FINAL DRAINAGE REPORT

MERIDIAN ROAD & BENT GRASS MEADOWS DRIVE

El Paso County, Colorado

DATE:
March 2020

Figure 5-3
Sub-Regional Detention Alternative
Falcon DBPS
El Paso County, CO

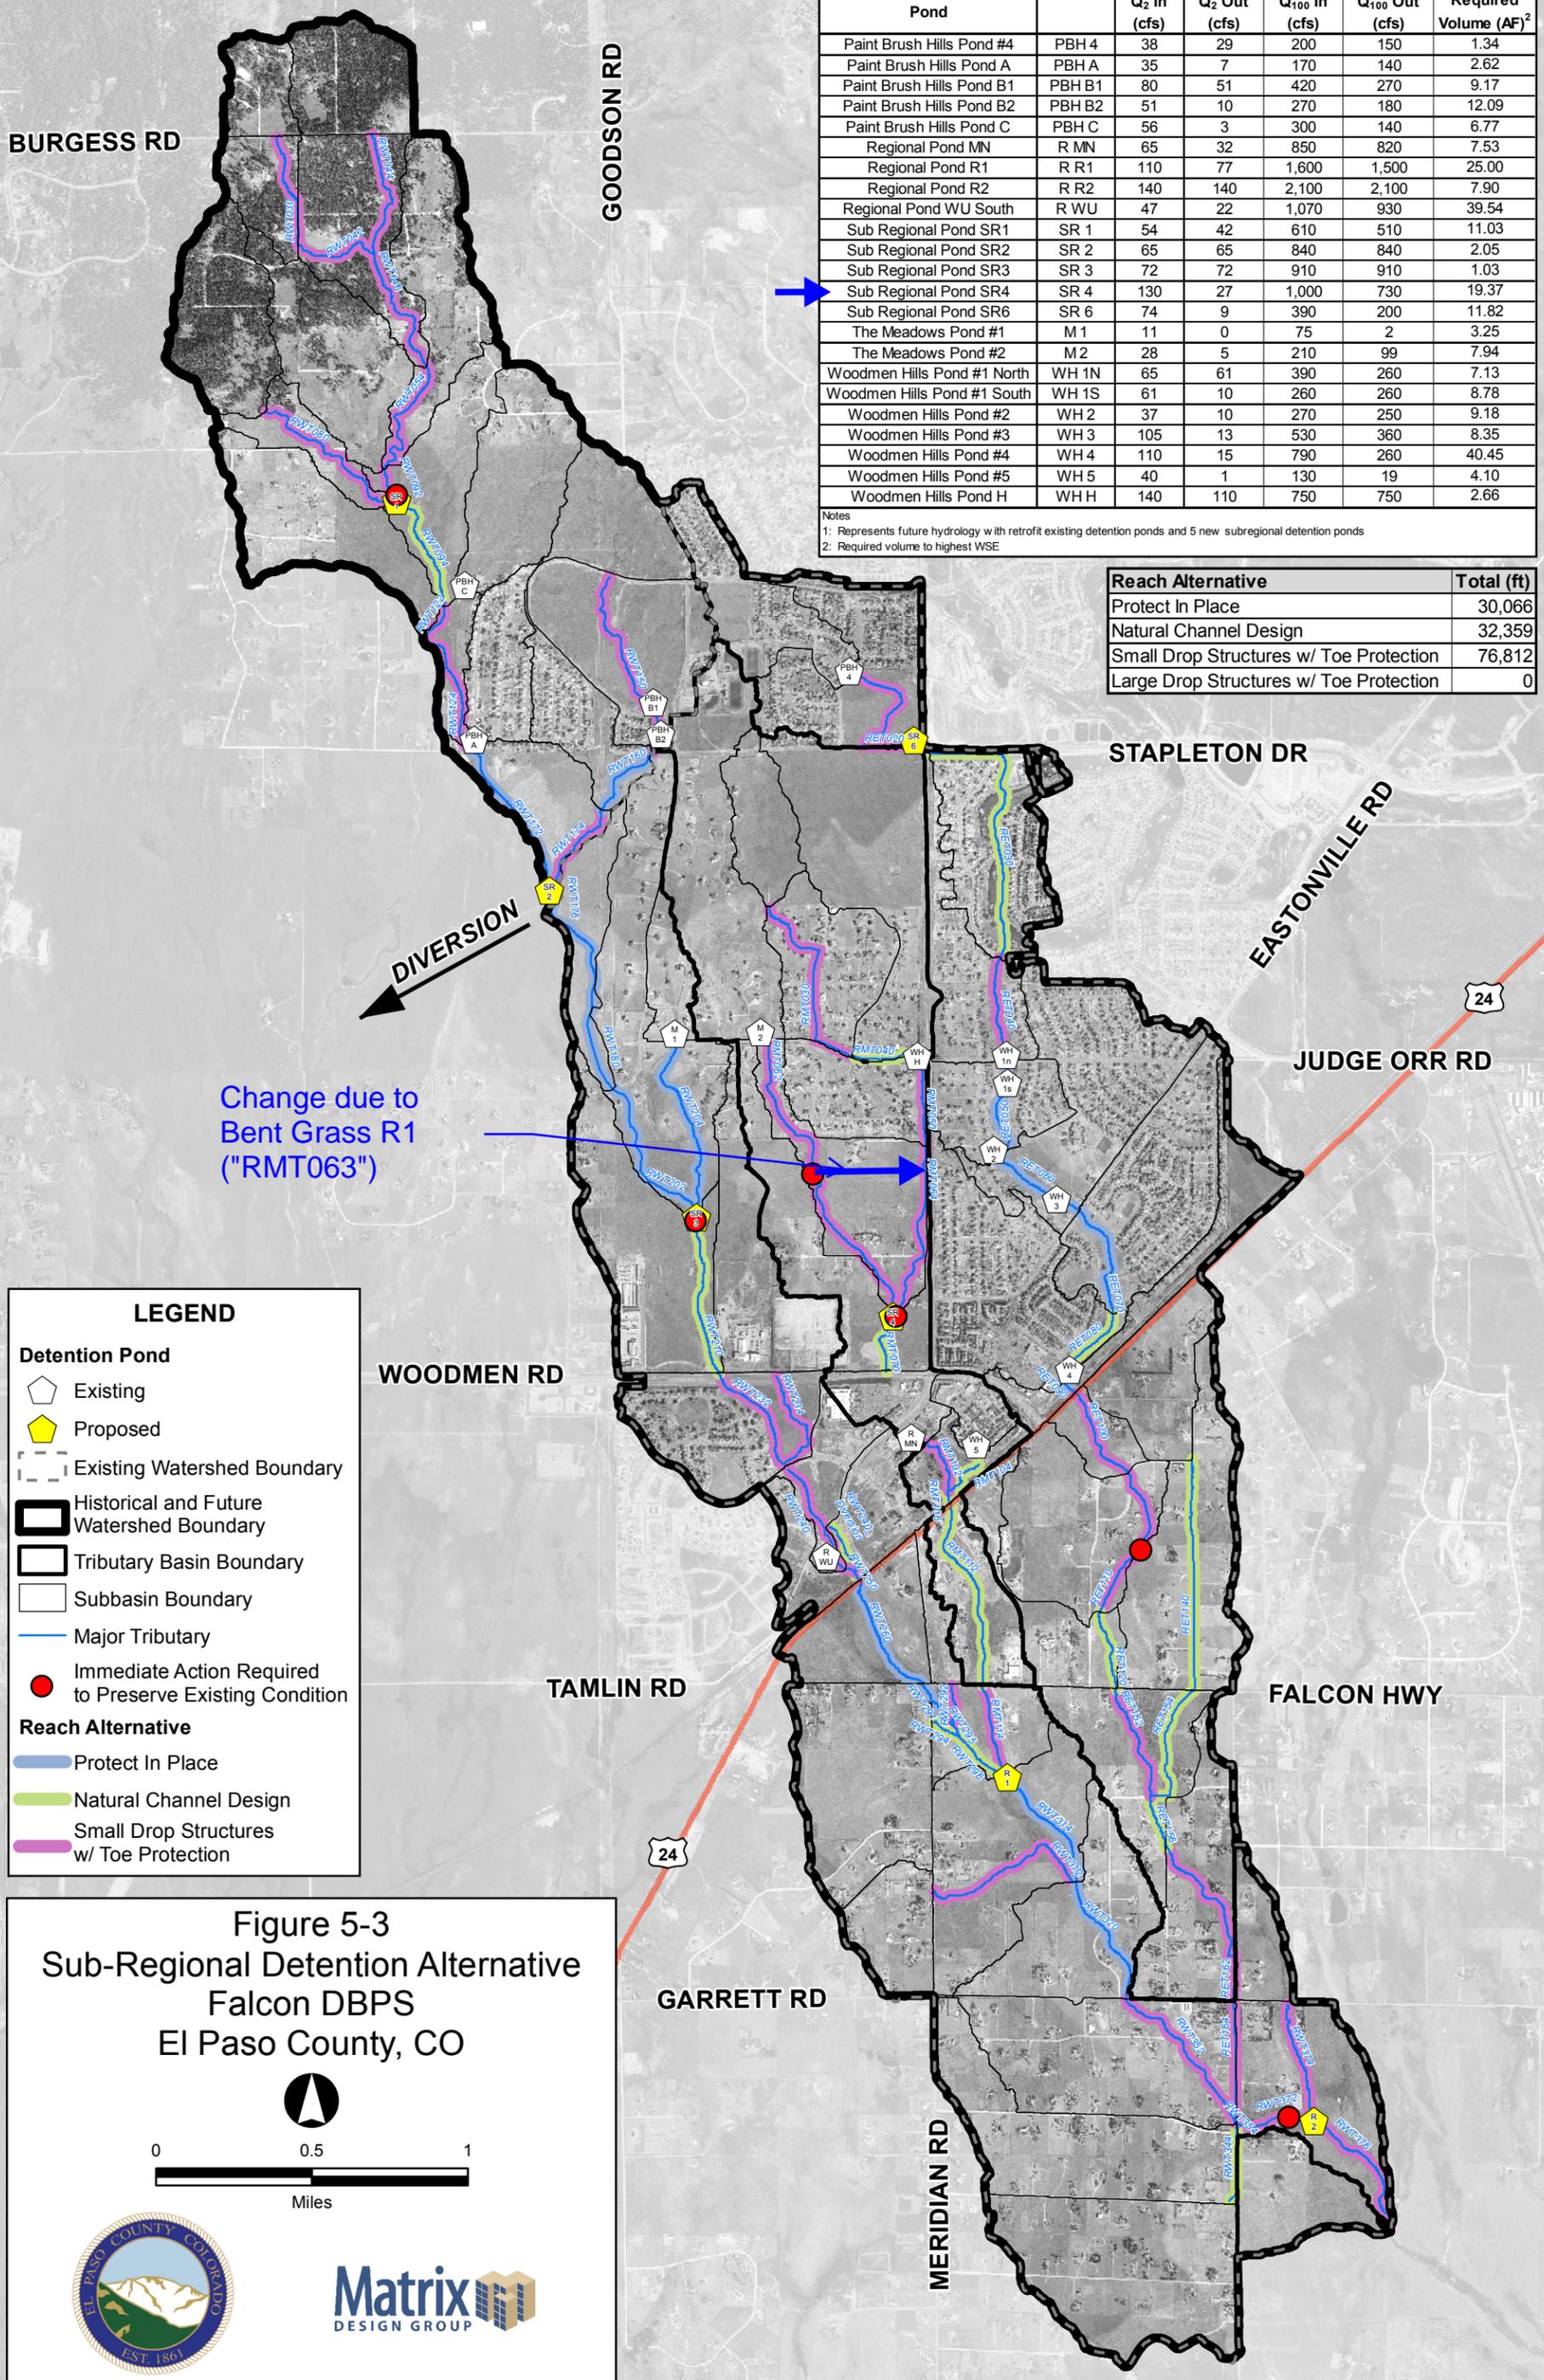
Change due to Bent Grass R1 ("RMT063")

Detention Basin Outlet Structure Design

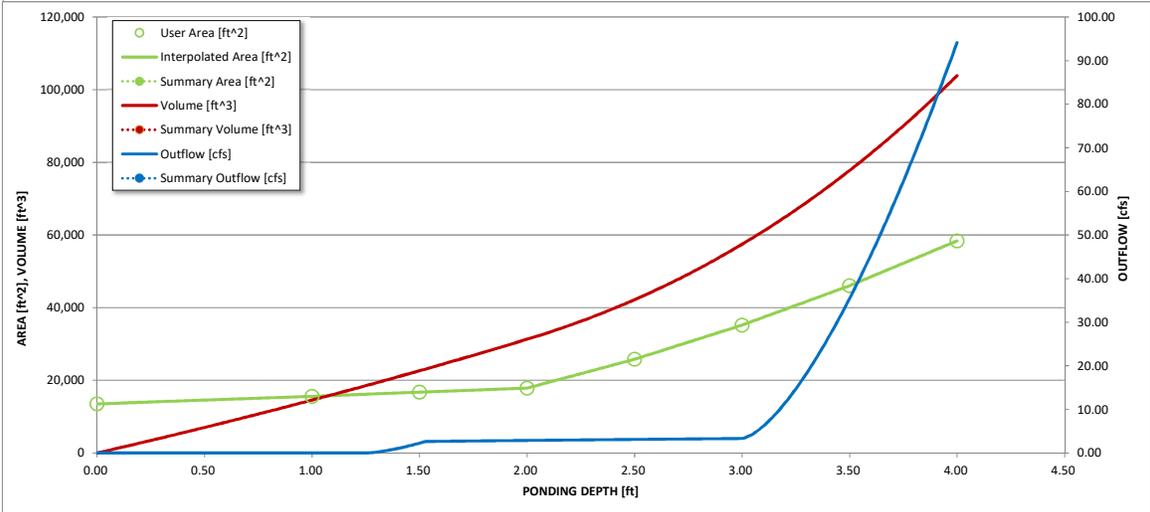
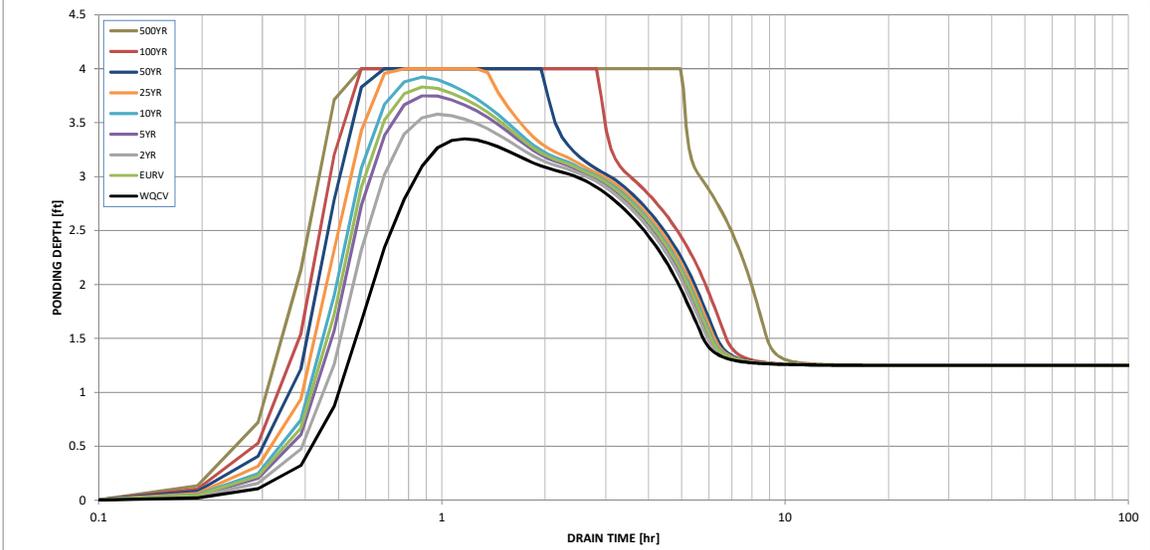
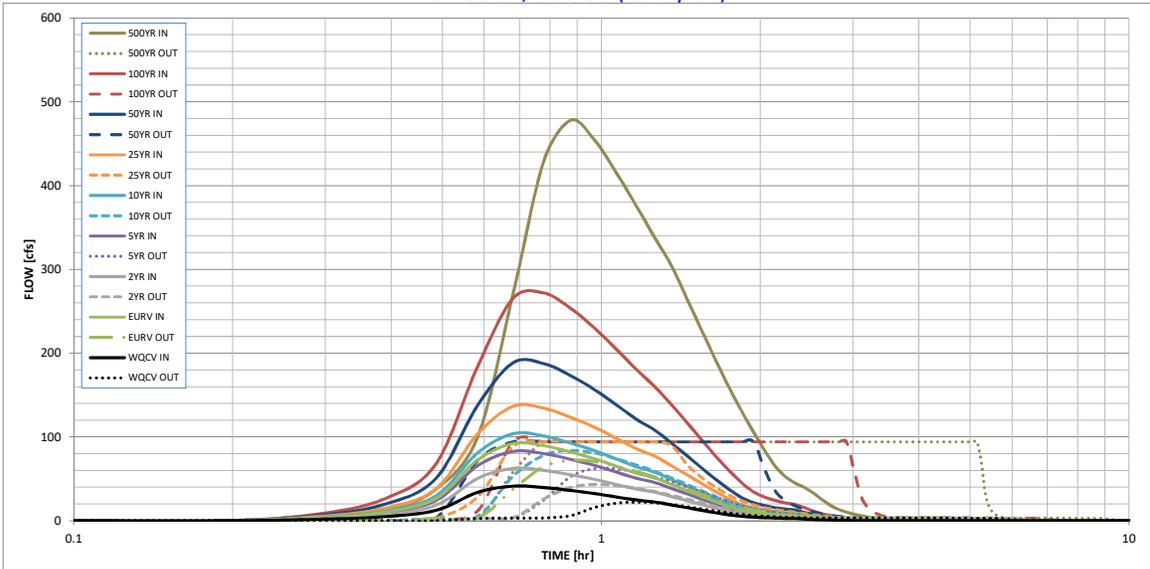
Something is wrong with calculations (pond volume)
